Migrating From FM25L256B To FM25V02A Or FM25W256

Author: Girija Chougala
Associated Part Family: FM25L256B, FM25V02A, and FM25W256
Related Documents: For a complete list, click here

AN308a discusses the key differences between FM25L256B, FM25V02A, and FM25W256 that need to be considered during migration from FM25L256B. FM25L256B is now obsolete and this application note explains how FM25V02A or FM25W256 is a replacement for FM25L256B.

Figure 1. 8-Pin DFN Package Outline

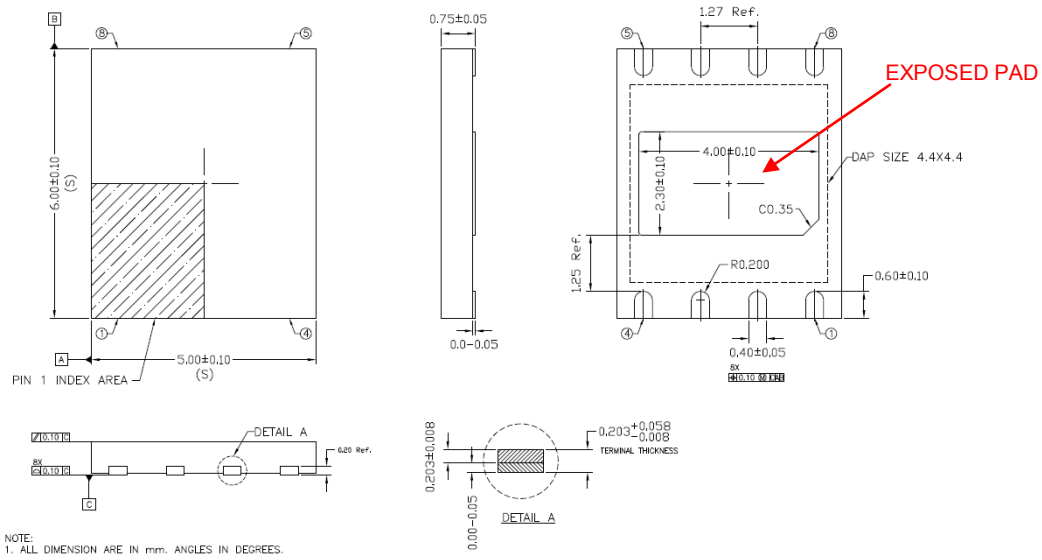
In both the FM25L256B and FM25V02A, the EXPOSED PAD of the DFN package is not connected to the die and must be left floating (in other words, no connect in the schematic design). The EXPOSED PAD in FM25V02A shown in the Figure 1 must not be soldered on the PCB. Soldering the EXPOSED PAD will cause the die to be exposed to excessive heat, which can result in bit failures and margin loss. Therefore, ensure that the EXPOSED PAD of the DFN package is masked on the PCB during the soldering process of the FM25V02A device.

There are two ways of masking the EXPOSED PAD, which is explained below:

1. Mask the Stencil opening for the EXPOSED PAD during stencil creation which can be done without updating the existing board layout design.

2. Mask the EXPOSED PAD in the solder paste film of the PCB design layout if you are designing a new board layout.
